**Re: Santa Clara SC-1 Data Center, Application for Small Power Plant Exemption -
Response to Informal Data Requests**

SANTA CLARA SC-1 DATA CENTER INFORMATION REQUESTS

**NO₂ Air Quality Impact Analysis &
Diesel Particulate Health Risk
Assessment for Xeres Ventures, LLC
Santa Clara Data Center
Santa Clara, California**

FACILITY
PLOT PLAN

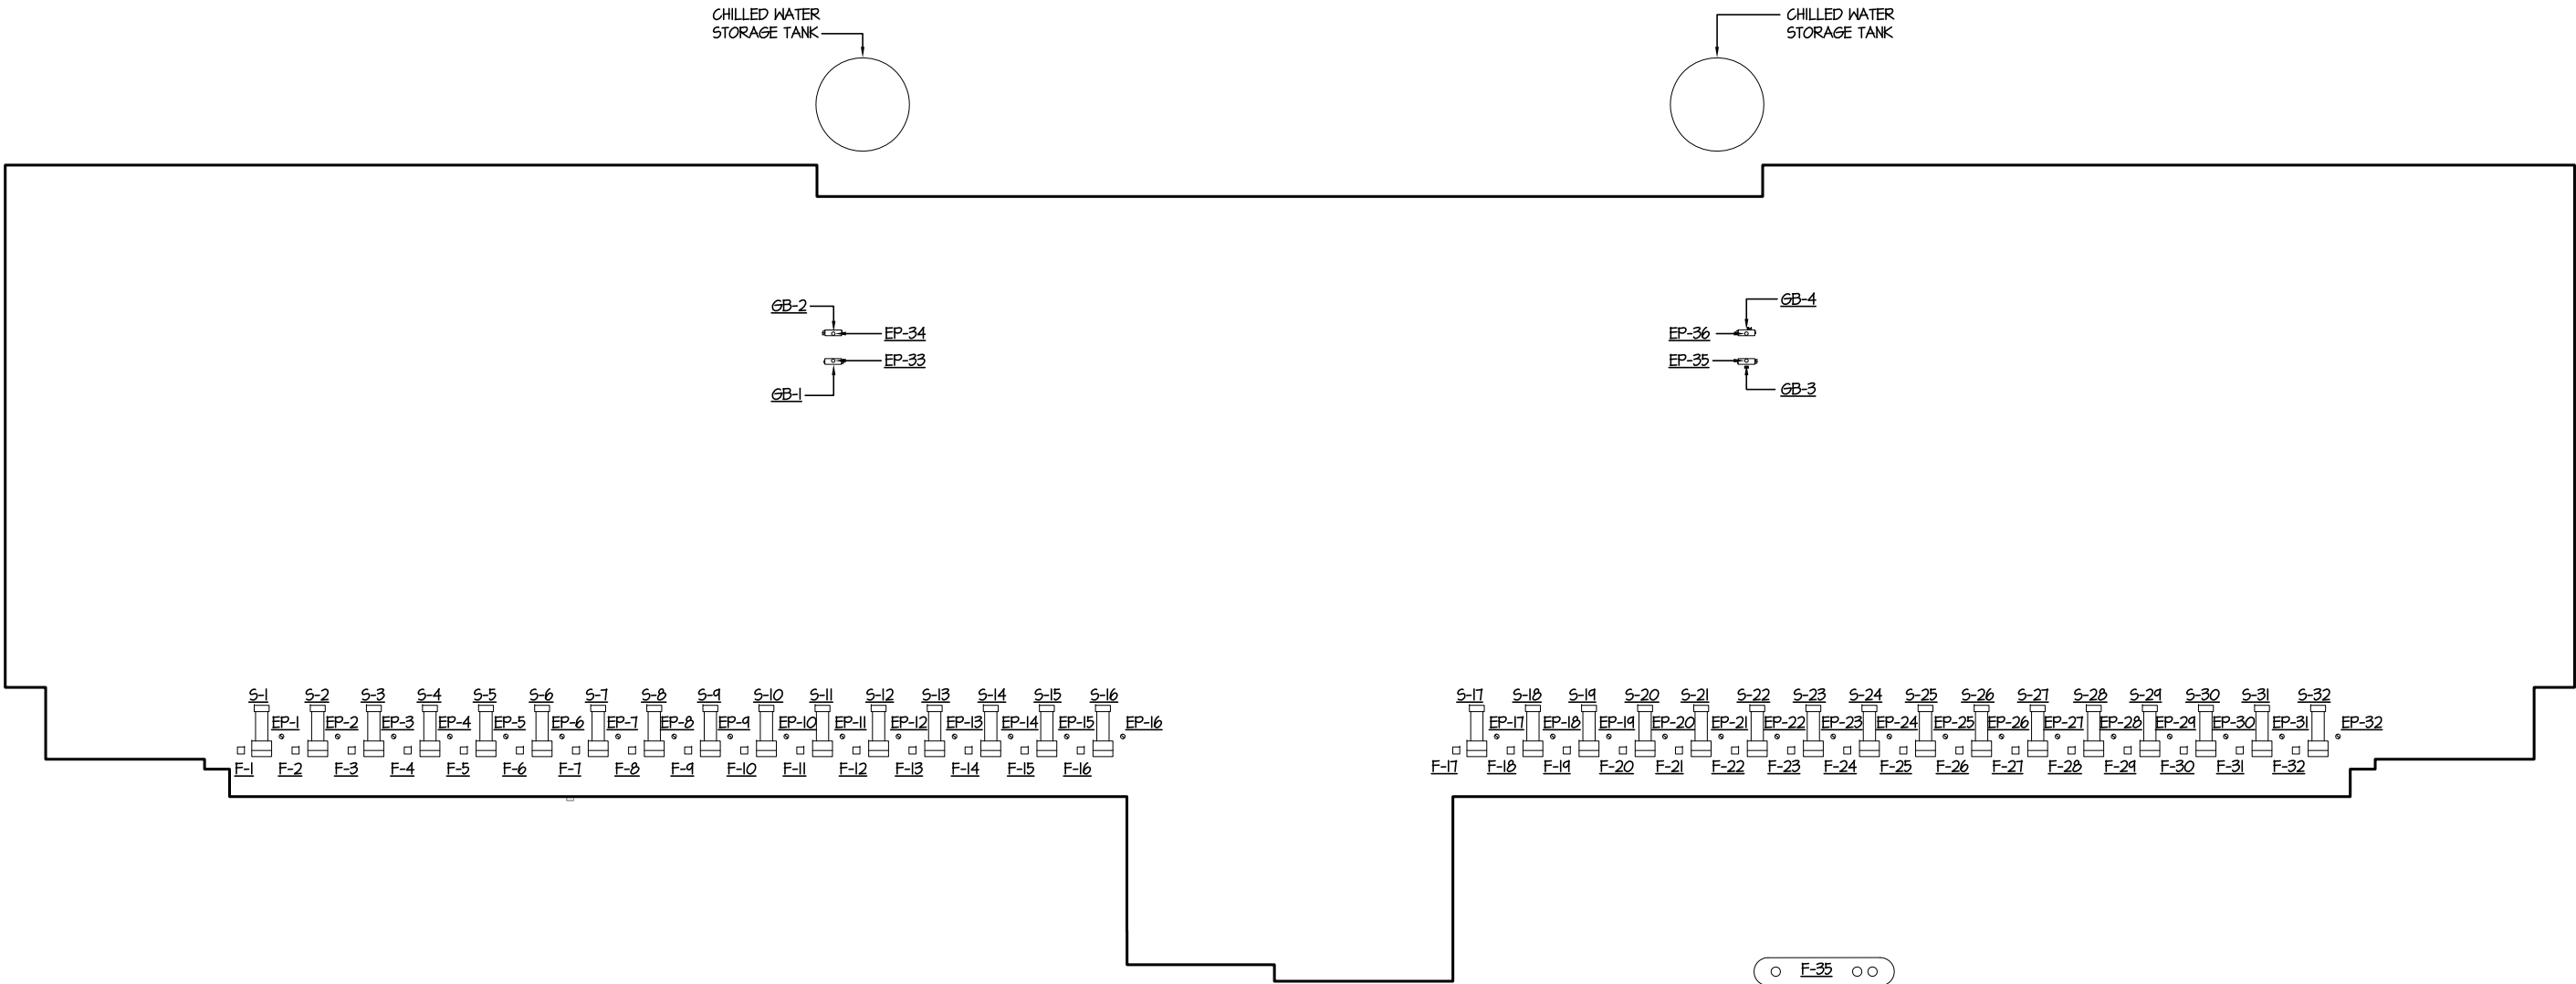
3. Please confirm that there will be two cooling towers on site. Provide a description of the location and orientation of the cooling towers (i.e., to-scale drawing that shows the layout of the cooling towers).

RESPONSE: *Upon completion of Phase I and Phase II of the project, there would be two cooling towers for computer server room cooling, each with eight (8) cells. Two of the eight cells would be redundant and only operate in case of failure of other cells. Cooling tower locations are shown in Attachment A. The dimensions of the cooling tower units are shown in Attachment B of this information response document.*

LOCATION OF BACKUP GENERATORS (IC ENGINES)

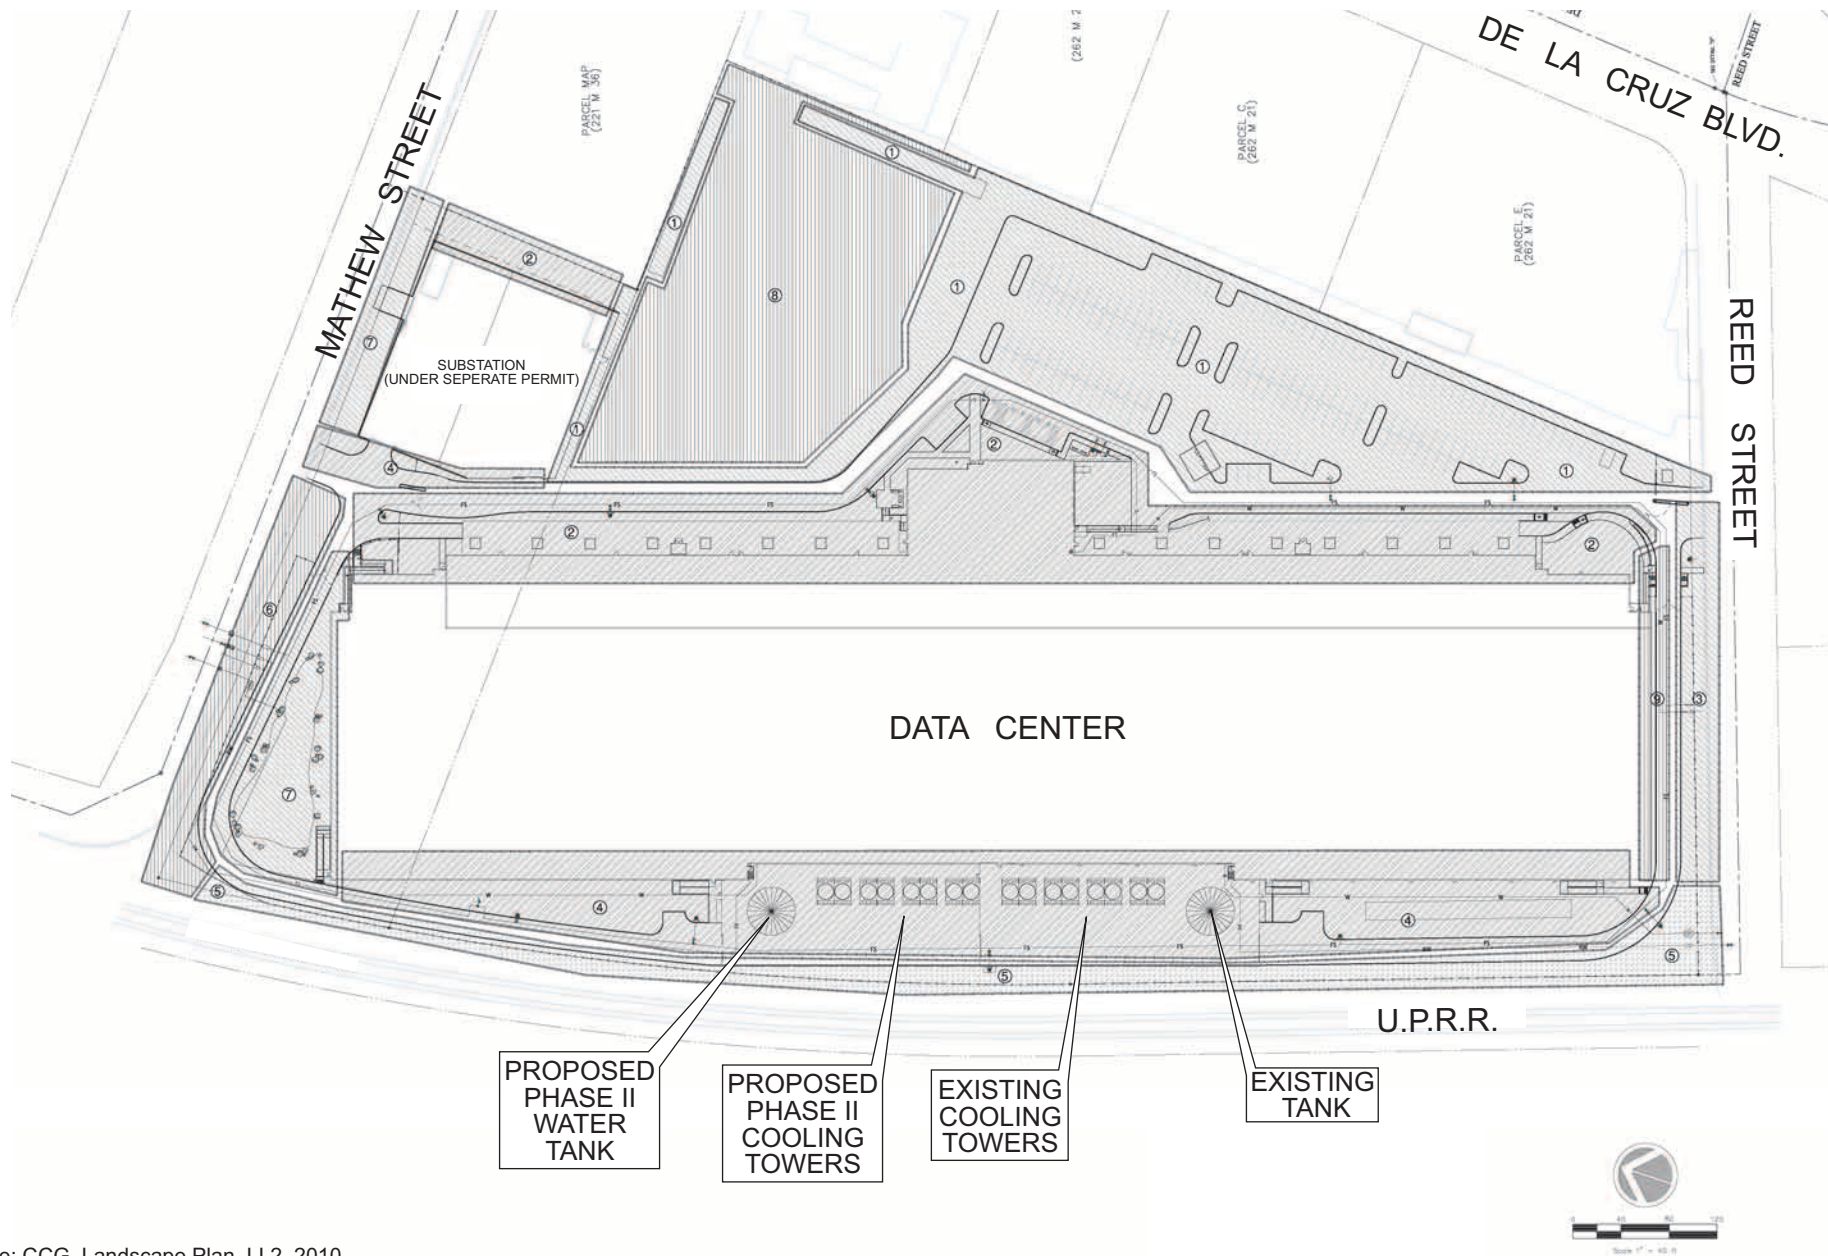
2. Please provide a description of the IC engines exhaust stacks including; location, orientation and quantity (i.e., to-scale drawing that shows all engine stacks, new and existing).

RESPONSE: All 32 stacks were modeled. The stack locations and elevations were obtained from the ISCST3 model input file that the Bay Area Air Quality Management District provided to Sierra Research. Sierra confirmed that the location of these stacks fit the location of the engine block area on the DFT site plan. A copy of the site plan is included as Attachment A. The UTM coordinates (NAD 27) used to model emissions from the 32 emergency generators are summarized below:

Fogging Frequency Estimate Curve

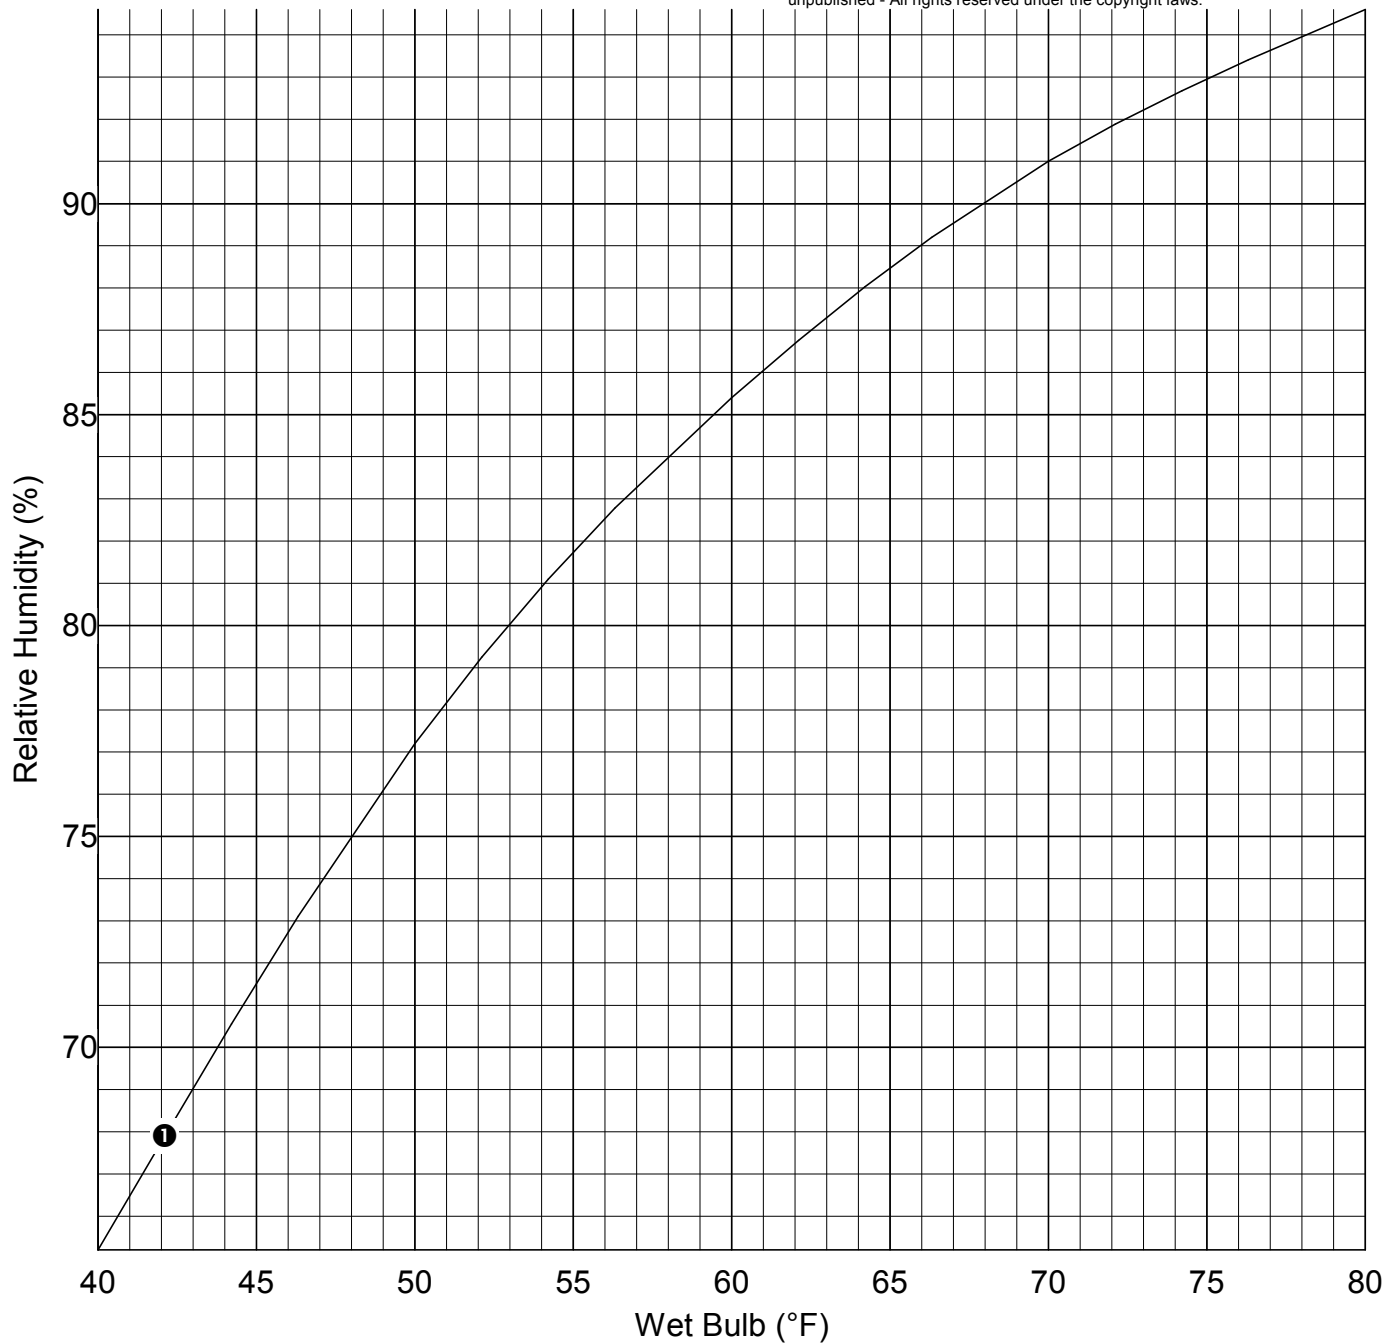
6. Please provide the cooling tower manufacturer and model number information and a fogging frequency curve from the cooling tower vendor for the cooling towers

RESPONSE: *The manufacturer is Marley and the model number is NC8412TAS-01. Attachment C is a "Fogging Frequency Estimate Curve" for one cell of NC8412TAS-01 operating with 3240 gpm/cell at 91.4/81.4/71°F.*
